Docket Item # 5
BAR CASE # 2018-00341

BAR Meeting
September 5, 2018

ISSUE: Partial Demolition/Capsulation

LOCATION: 820 South Fairfax Street

Figure 1: Existing east elevation, not visible from the public right-of-way.

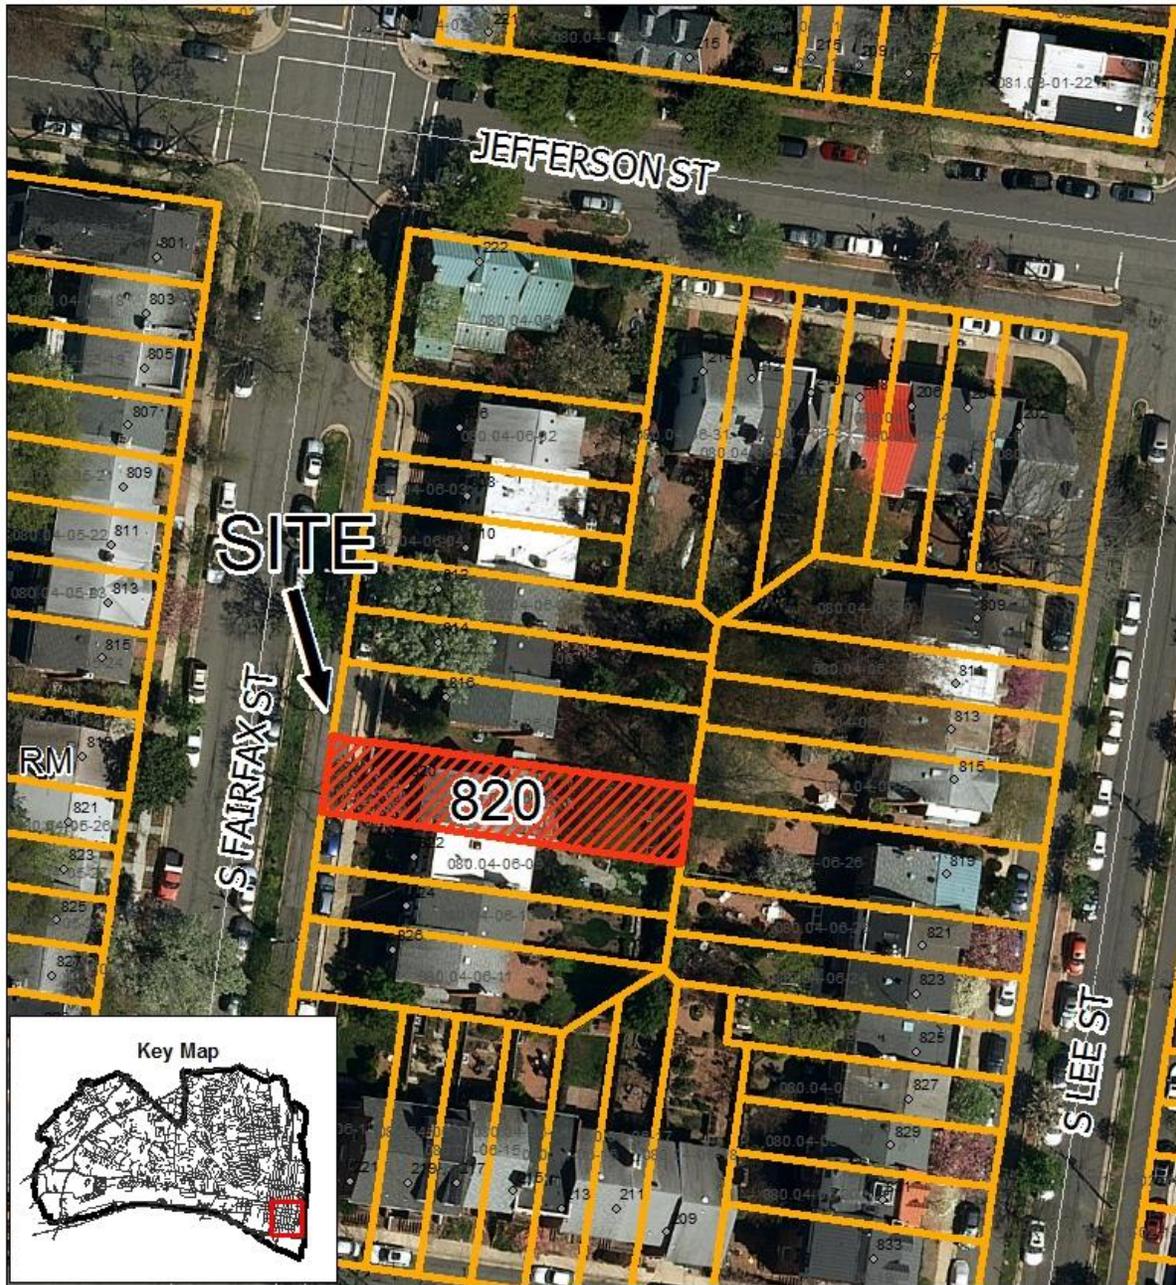
Staff has no objection to the demolition/capsulation of a portion of the east elevation. The partial demolition will occur on the rear of the property and is not visible from the public right-of-way. The materials and details are not old and unusual or uncommon and this structure could be reproduced easily using modern materials.

Staff recommends approval of the Permit to Demolish/Capsulate as submitted.
